UNITED STATES PATENT AND TRADEMARK OFFICE

Office Action Summary	Application No. 10/586,144	Applicant(s) EASON ET AL.	
	Examiner CHRISTOPHER UHLIR	Art Unit 2832

DETAILED ACTION

Figure 1: Pivot coupler
orientated in Torrez

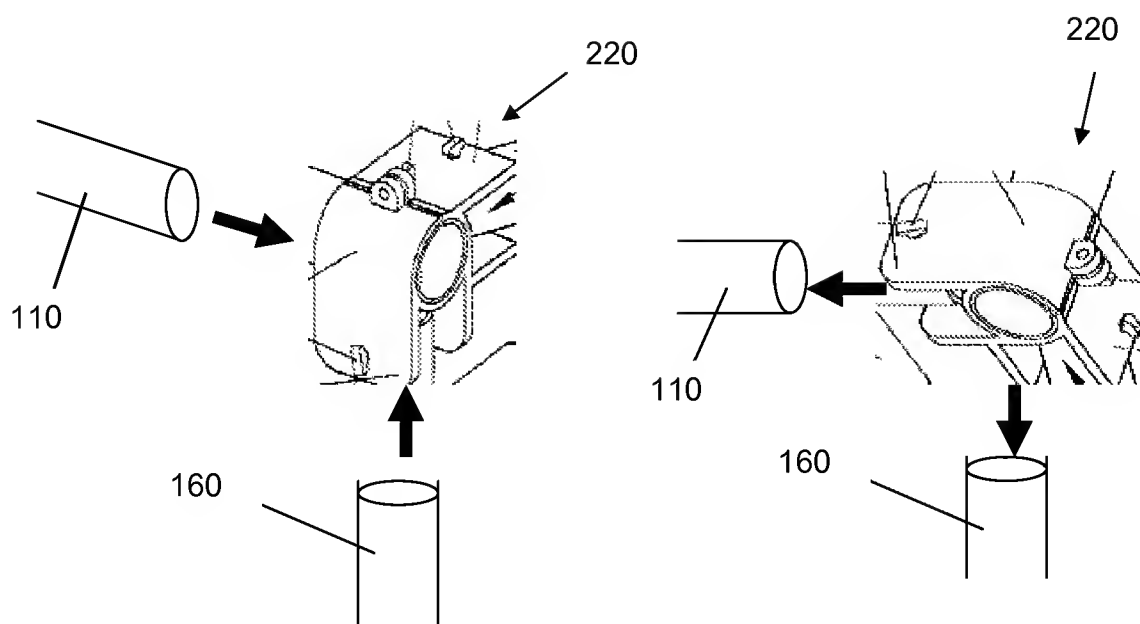
However the support apparatus disclosed by Torrez could be modified by rotating the pivot coupler (220) 90° as shown in Figure 2 below. This would provide the pivot coupler (220) to enable rotatable motion of the item support rail (110) about the substantially vertical axis defined by the rail support leg (150/160), and enable substantially purely vertical translatory height adjustment of the item support rail (120) relative to the rail support leg (150) through loosening and tightening thumb screw (225). Therefore, it would have been obvious to one of ordinary skill in the art at the time the invention was made to provide the pivot coupler to enable rotatable motion of the item support rail about the substantially vertical axis, where the pivot coupler enables substantially purely vertical translatory height adjustment of one of the item support rails relative to one of the rail support legs to which it is pivotally connected since it has been held that the provision of adjustability, where needed, involves only routine skill in the art. In *re Stevens*, 101 USPQ 284 (CCPA 1954). It has further been held that rearranging parts of an invention involves only routine skill in the art. In *re Japikse*, 86 USPQ 70. Doing so would provide a “wide degree of horizontal and vertical relative adjustment of percussion instruments” through a collapsible rack, as taught by Lombardi (column 2 lines 15-18).

However the support apparatus disclosed by Torrez could be modified by rotating the pivot couplers (220, 230) 90° as shown in Figure 2 above. This would provide the pivot couplers (220, 230) to enable rotatable motion of the item support rail (110) about the substantially vertical axis defined by the rail support legs (150/160), and enable substantially purely vertical translatory height adjustment of the item support rails (120/130) relative to the rail support legs (150/160) through loosening and tightening thumb screw (225). Therefore, it would have been obvious to one of ordinary skill in the art at the time the invention was made to provide the pivot couplers to be rotatable about the substantially vertical axis, where the pivot couplers are also height adjust couplers that enable substantially purely vertical translatory height adjustment of an item support rail. It would further be obvious to one of ordinary skill in the art at the time the invention was made to provide a portion of the item support rail to be sized to

In reference to claim 51, Torrez modified by Lombardi discloses a support apparatus as stated above, where the first and second compressible elements is shown in Figure 2 above to be installed around the rail terminus and a portion of the rail support leg (150/160). These references fail to explicitly disclose the cable to enter an item support rail without pre-drilling of either the item support rail or a portion of a rail support leg.
